# **Product Change Notification**

## **113766 - 01**

**Change Notification #:** 113766 - 01  
**Change Title:** Intel® Compute Module HNS2600WP & HNS2600WPQ  
PCN 113766-01, Product Design  
Change the material of tray latch cap from rubber to polycarbonate  
**Reason for Revision: Additional Product Added**  
**Date of Publication:** July 15, 2015

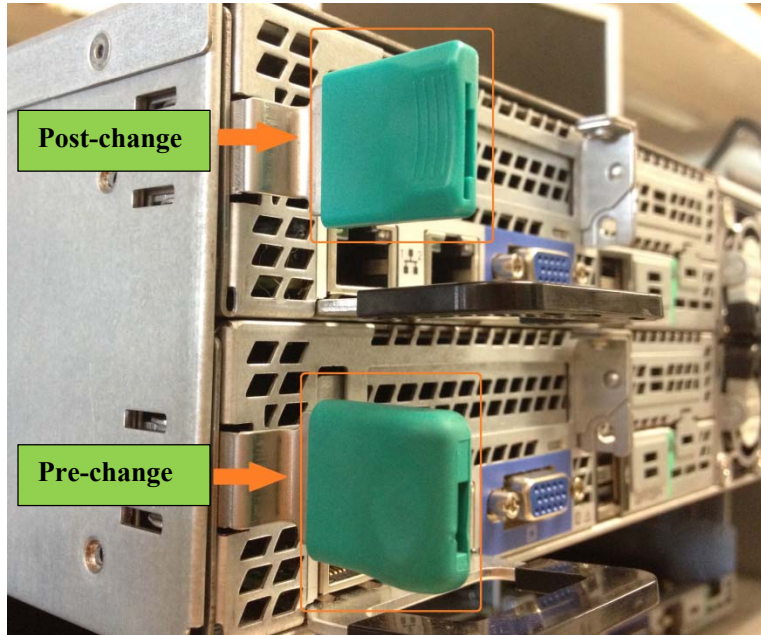
Change the material of tray latch cap from rubber to polycarbonate to avoid pulling the cap out from the tray latch.

See below picture: the lower one is pre-change cap and the upper one is post-change cap.
